## TE Connectivity

Product Change Notification: P-20-019511

2834171-3 package tape changing

## 2834171-3 Carrier Tape Improvement

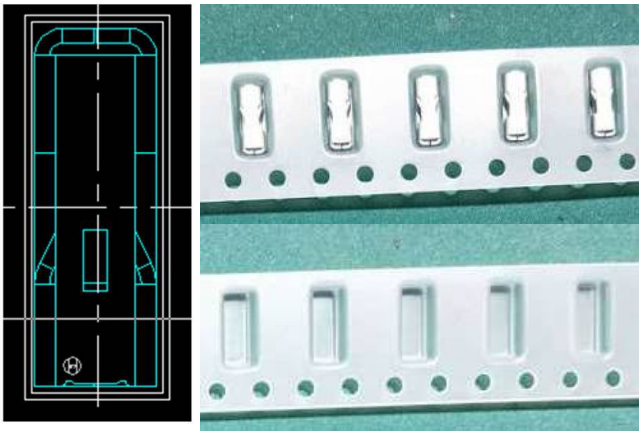
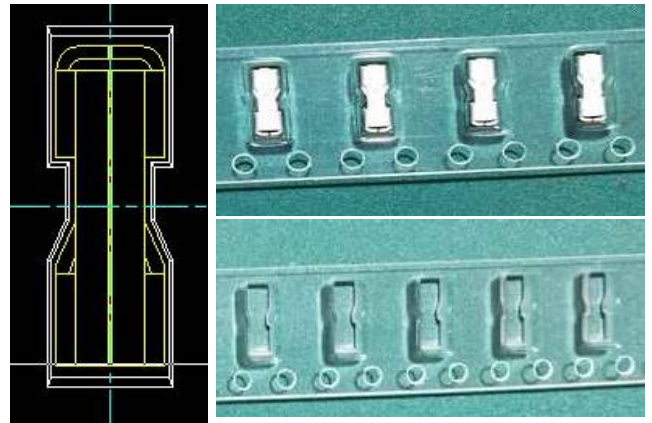
Update the carrier tape cave structure to improve the product pick&up appliaction
